INFORMATION NOTICE

15K ADJUSTABLE COUPLER WELD INSPECTION OF MPD 81906

3/16/07

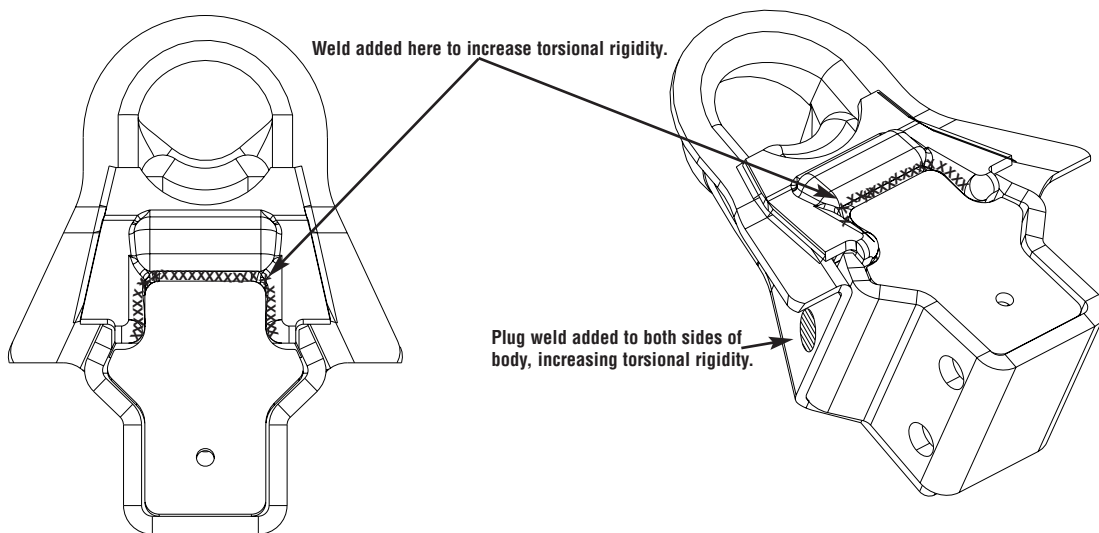
In order to improve torsional rigidity and compressive strength, a continuous weld has been placed along the outer perimeter of the Bottom Mount Bracket where it mates to the Adjustable Mounting Bracket. A plug weld has also been added to the forward wing of the Adjustable Mounting Bracket creating a mechanical joint between the Mounting Bracket and the body of the Coupler. Please inspect all 15K Adjustable Couplers, P/N 81906, that you have in your inventory for welds.

LOCATE THE WELDS AS NOTED IN THE ABOVE DRAWING

Couplers that do not exhibit the welds as identified in the verbiage and picture above must be removed and/or isolated.
